ORCHARD GATE, NOADS WAY, DIBDEN PURLIEU, HYTHE SO45 4PD

PINS Ref: APP/B1740/W/23/3324227
LPA Ref: 22/10813

PROOF OF EVIDENCE

Richard Stephen Payne CMLI MA BSc

Fig T. Diagram representing the proposal site – a potential ‘backland development’

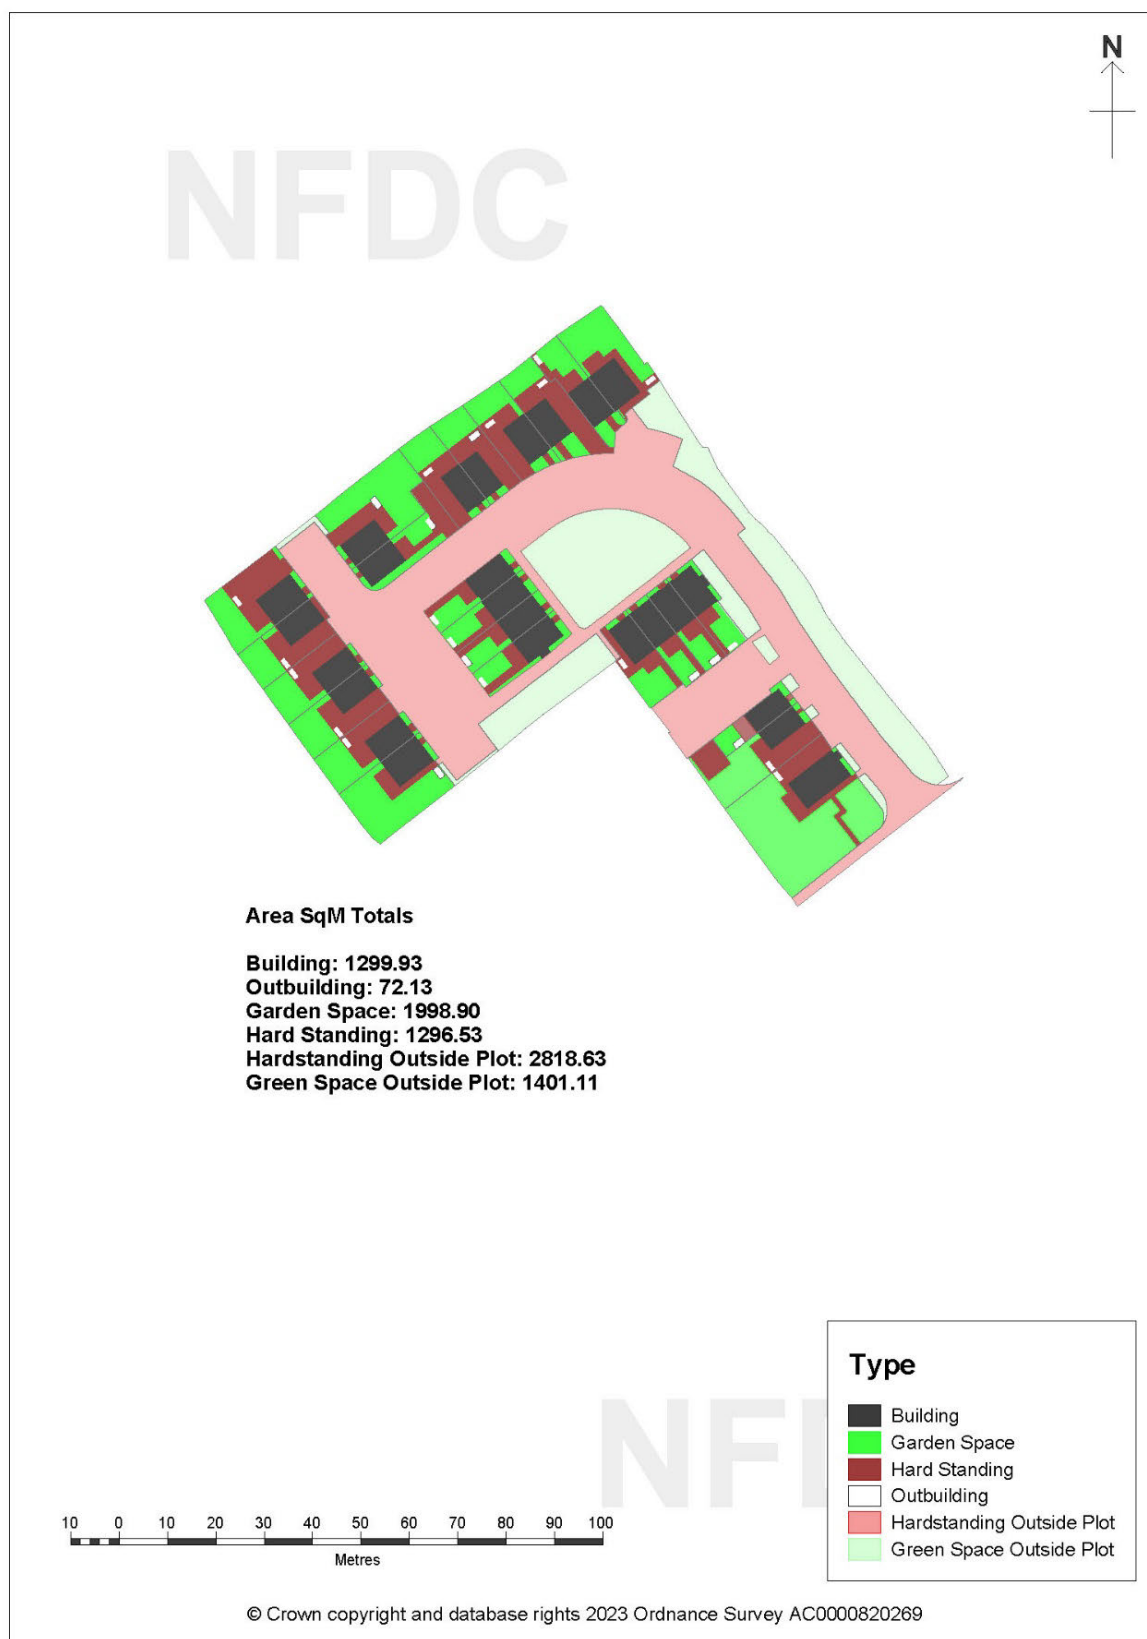
Example plot areas include 22 or 23 where available greenspace to rear of properties is around 30sq m whereas around 80sq m is covered by built form and hard standing and this is without considering car parking. Plots 17-20 have around 50 sq m of garden space available to plant in, however, approximately 2/3 of this is within 9m of, and directly behind the rear elevation of the home. It is thus unlikely to invite planting of any significance. 120sqm of the plot is given over to hard surface or building. These ratios are not just severely at odds with local character but they deny the likelihood that enough planting opportunities can be accommodated within the plots to respect or enhance the locally distinctive character in any way. See Appendix B diagrams.

There is not enough room on most of these plots to encourage residents to plant trees that could enhance the locally distinctive character of the area. Garden space is calculated at about 80 sq m (one tenth of the size of those on neighbouring plots).

Fig U. Diagram representing the neighbouring plots as well as the proposal in situ in the analysis area, showing the stark contrast between the proportions of green space to built land on the neighbouring plots as compared with the proposal.

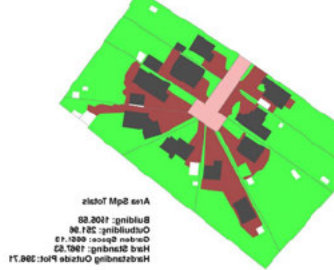
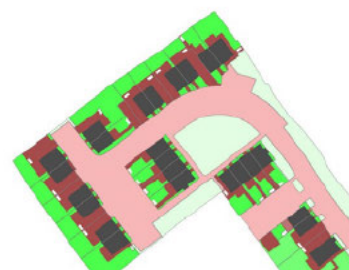
- 6.4.9 Whilst even a more respectful approach would still have depleted the overall cumulative value that gardens grouped together give to this neighbourhood, Figure 7 below demonstrates a very severe departure from contextual design and an unmitigated fragmentation of the cumulative garden island.
